The Fitzroy Park Residents' Association

RE: APPLICATION NO: 2016/3252/P - 4 THE HEXAGON, FITZROY PARK, N6

Report to FPRA

SUPPORTING PHOTOGRAPHS:

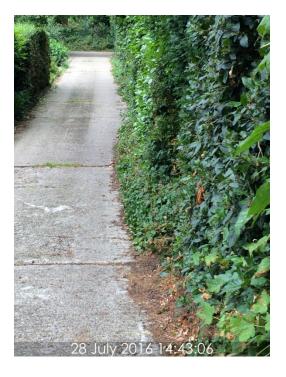
Slope down from Fitzroy Park to the development site to the rear right.

2.8m wide pinch point

Encroachment of verges and hedges limiting further accessible width of the Hexagon

7 cars are parked in this photograph. The proposal is to suspend 19 parking spaces along the entire length of the allotment verge.
